3. McCall Subdivision 2022 Replat KPB File 2022-166

McCall Subdivision, 2022 Replat Preliminary Plat

ITEM 3 - MCCALL SUBDIVISION 2022 REPLAT

STAFF REPORT

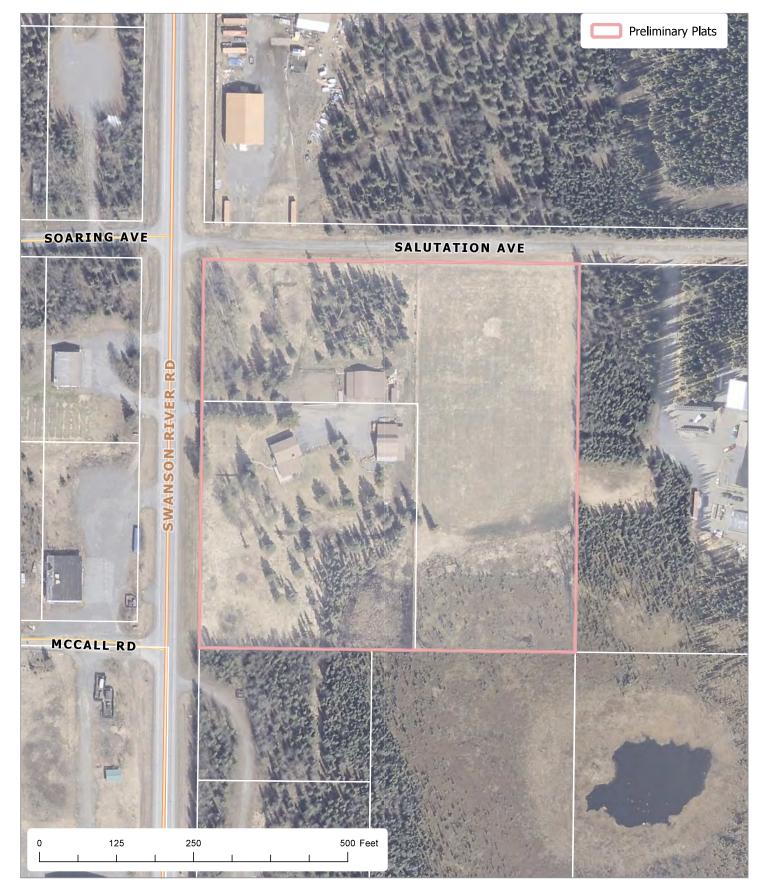
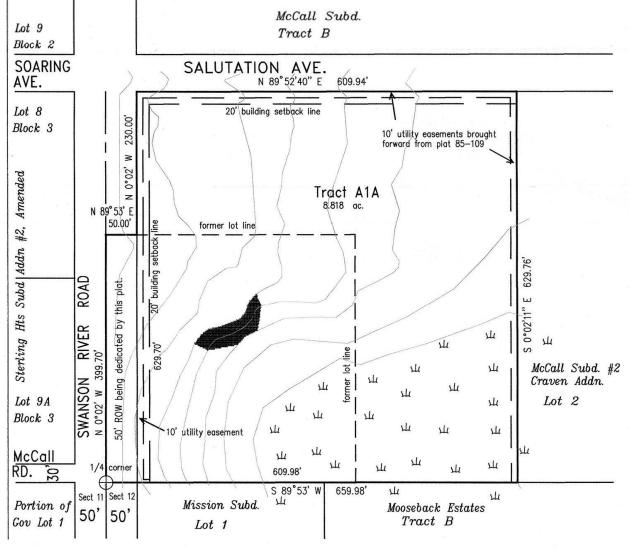
Section line easements are located within the Swanson River Road dedication. The section line easements do not need to be noted except in relation to the depiction of the Government Lot located to the southwest. That lot has not been platted and the Swanson River Road dedication does not appear to have occurred. The lot depiction should be revised and it should be noted that a section line easement is present.

<u>Site Investigation:</u> Low wet areas are present within the southeastern portion of the subdivision. **Staff recommends** the depiction of the low wet areas remain on the final plat and a wetlands determination note be added.

A small area of steep slopes is present within the deed parcel. The impact to development is minimal and existing structures are on the property. **Staff recommends** contours and steep slopes may be removed from the final plat.

<u>Utility Easements</u> McCall Subdivision, Plat KN 76-176, did not create any utility easements to carry over as the standard easements along dedicated rights-of-way were not required. A building setback was created. McCall Subdivision No. 2, Plat KN 85-109, granted 10 foot utility easements along Salutation Avenue, originally named Hi Avenue, and along the eastern property line. The plat has carried over the easements. **Staff recommends** the label for the easement be revised to state "granted by plat KN 85-109".

This plat will be granting 10 foot utility easements that increase to 20 feet within 5 feet of the side lot lines. These easements will be granted along Swanson River Road's existing dedication and the new dedication. **Staff recommends** the label include "granted by this plat".

Add legend to drawing

Staff recommendation: The legal description will need to include more information regarding the deed parcel. As the legal description is long it may state "Deed parcel as described in warranty deed found in Book 188, Page 86, KRD.

- C. The location, width, and name of existing or platted streets and public ways, railroad rights-of-way, and other important features such as section lines or political subdivisions or municipal corporation boundaries abutting the subdivision;
 - Staff recommendation: Provide a width label for Salutation Avenue.
- G. The status of adjacent lands within 100 feet of the proposed subdivision boundary or the land status across from any dedicated rights-of-way that adjoin the propose subdivision boundary, including names of subdivisions, lot lines, block numbers, lot numbers, rights-of-way; or an indication that the adjacent land is not subdivided:

Staff recommendation: It appears that the portion of Government Lot 1 should be drawn to the section line with the section line easement labeled for that portion. Width label for Soaring Avenue should be added and update McCall Road width to 40 foot for the portion shown.

Platting Staff Comments: Soils report is not required as lots are increasing in size and will be over 200,000 square feet. Add correct wastewater disposal notes.

Staff recommendation: The dedication of Swanson River Road will need to be accepted by State of Alaska DOT. Please work with DOT for correct authorized personnel and acquiring signature.

Check plat note numbers before submitting the final.

Plat note 3 should include the original date with amendments being noted with their dates.

Plat note 4, replace "Kenai Records" with "Kenai Recording District" or "KRD".

- "No access to state maintained rights-of-way permitted unless approved by the State of Alaska Department of Transportation."
 - WASTEWATER DISPOSAL: Wastewater treatment and disposal systems must meet the regulatory requirements of the Alaska Department of Environmental Conservation.

- Restriction apply for water well locations per the terms and conditions within Book 286 Page 651, KRD.
 - The borough will not enforce private covenants, easements, or deed restrictions per KPB 20.60.170.

- Any person developing the property is responsible for obtaining all required local, state, and federal permits, including a U.S. Army Corps of Engineers wetland determination if applicable.
